GULF STATES UTILITIES COMPANY

August 14, 1985
RBG-21859
File No. G9.5

River Bend Station-Unit 1
Docket No. 50-458

As requested by your Staff, enclosed are revisions to the Gulf States Utilities River Bend Station Environmental Qualification Document, Appendix B.1, System Component Evaluation Work (SCEW) sheet SRN 247491-3. These revisions support the justification for interim operation for two air operated valves (1DFR*A0V144 and 145) in the suppression pool pump-back system previously provided in GSU's August 13, 1985 letter.

SHEET NO. 3

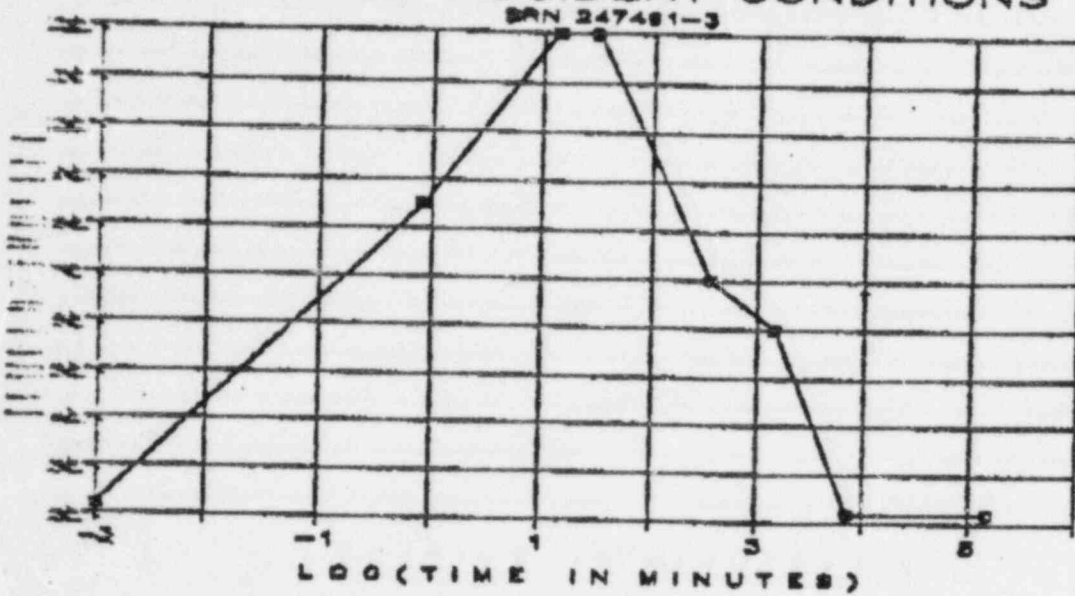
1. For complete environmental conditions, see ^{documents}~~conditions~~ referenced. X
2. For qualified life, see Reference 4. In the qualified life calculation, the temperature rise ^{coil}~~by the actuated coil~~ is considered. X
3. Operability time extended from 30 to 100 days plus margin by the Arrhenius calculation. See Reference 4.
4. The qualified life of this component can be extended to 40 years by periodic maintenance or replacement. See References 2 and 4.
5. Safety Functions - Control steam pressure in heat exchanger; control heat exchange water level; ~~and~~ standby service water isolation valve for penetration valve leakage; control compressor; and isolate auxiliary building floor drains. X
